**RBC List of discrepancies between the Design Code (May 2022 - ID25) and
Parameter Plans and other matters not agreed within the Design Code
13/7/22**

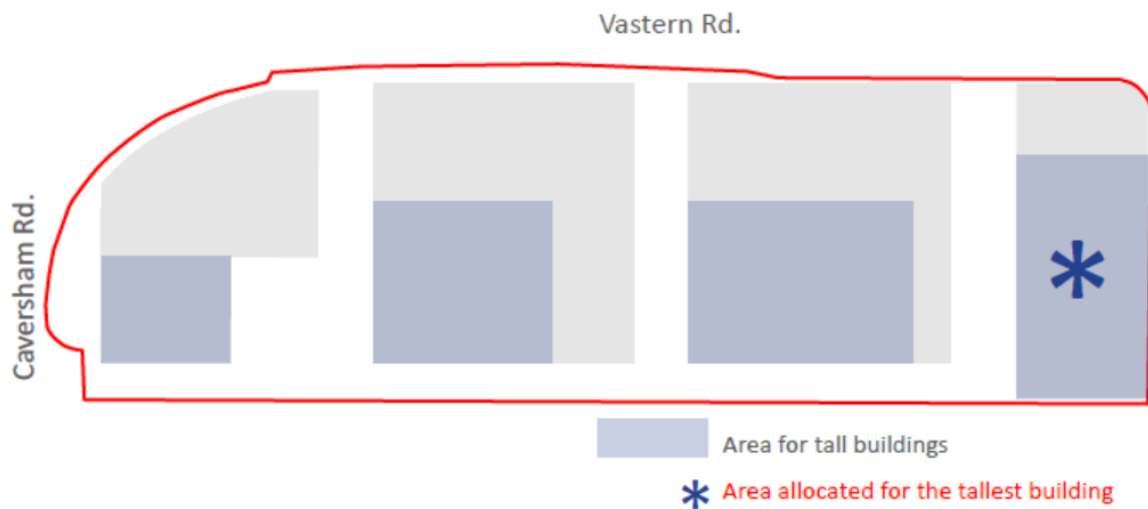
Paragraph 5.1.4 - *“The main vehicular route could deviate anywhere within the blue hatched Zone, which is determined by PP-102_P2 - Parameter Plan - Building Plots and access points shown on PP-101_P1 - Parameter Plan - Site Access & Egress. After the main route has been provided, additional public routes could be introduced.”* These PP do not show the main vehicular route.
